**SUPPLEMENT TO REQUEST FOR CHANGE TO TECHNICAL SPECIFICATIONS  
SAFETY LIMIT MINIMUM CRITICAL POWER RATIO  
HOPE CREEK GENERATING STATION  
FACILITY OPERATING LICENSE NPF-57  
DOCKET NO. 50-354**

**Additional Information Regarding the Cycle Specific SLMCPR for  
Hope Creek Cycle 13  
(Non-proprietary version)**

**Responses to Draft Request for Additional Information  
by the Office of Nuclear Reactor Regulation  
Relating to Requested Amendment to License No. NPF-57  
PSEG Nuclear LLC Company  
Hope Creek Generating Station  
Docket No. 50-354  
(Non-proprietary version)**

**Figure 1  
Reference Loading Pattern – Hope Creek Cycle 13**

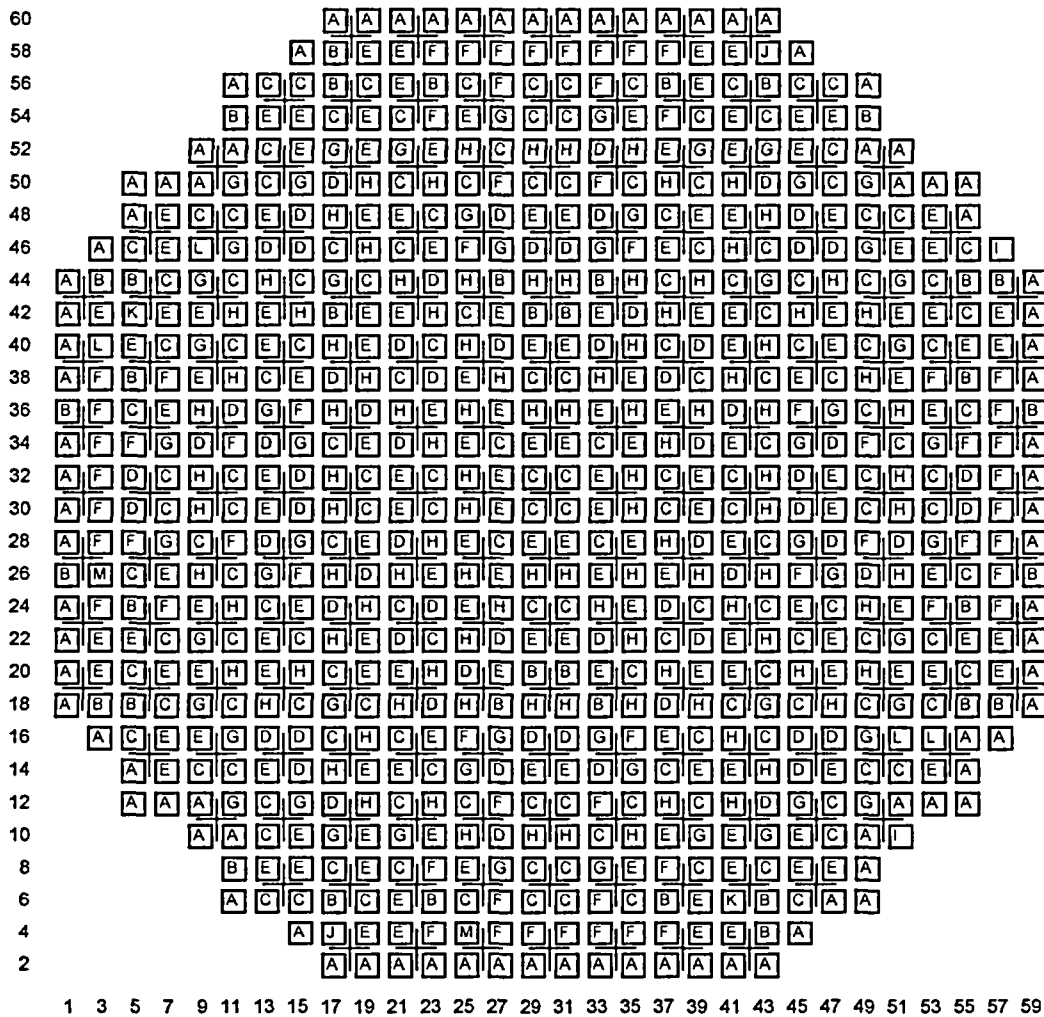
1. Describe the rationale for placing four twice burned type "C" fuel assemblies in the center of the core and twelve once burned type "E" fuel assemblies around the center core in a symmetric core loading pattern of the core design, as shown in Figure 1 of the non-proprietary version of the GNF document.

Response to RAI 1: In general, GNF core designs are quadrant symmetric. Therefore, the center cell usually consists of four bundles of the same design and operational history. Use of four twice-burnt bundles in the center cell is typical of GNF core designs for 18 month fuel cycles (such as Hope Creek Cycle 13). Four once-burnt or four fresh<sup>1</sup> bundles would usually be too reactive to satisfy shutdown margin and or thermal margin requirements. Use of thrice-burnt bundles is generally unnecessary in order to achieve reactivity and thermal margin design goals. The fuel surrounding the (twice-burnt) bundles in the center cell is generally fresh, once-burnt or a mixture of the two. Use of twice-burnt or thrice-burnt fuel surrounding the center cell would probably over-depress the power in the center region and thus compromise neutron economy. The bundle placement decision making process is guided by the requirement to maintain specific reactivity and thermal margin design goals while optimizing overall neutron economy.
